Remarks

Application/Control Number: 09/775,492 Art Unit: 2634

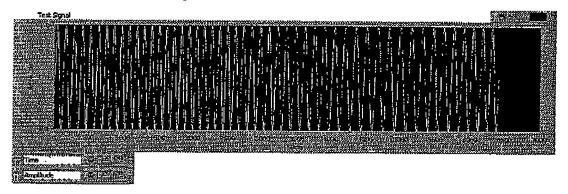
- a) it is not clear how the components connected as described in the specification and figures 2-3
 results in the complex signal converted from the real signal;
- b) the function of the first adder is not clear;
- c) the operation of the selector is not clear;
- d) the function of the multipliers is not clear.

The Multipliers 14 and 15 are multipliers or devices which perfrom a multiply operation such that Vout(t) = Vin(t) * Vmult(t).

Mixer is a term used in Rf to perform the multiplication function but while all multipliers are mixers, not all mixers are multipliers. As this process can be implemented in digital or analog domain, we prefer the term multiplier.
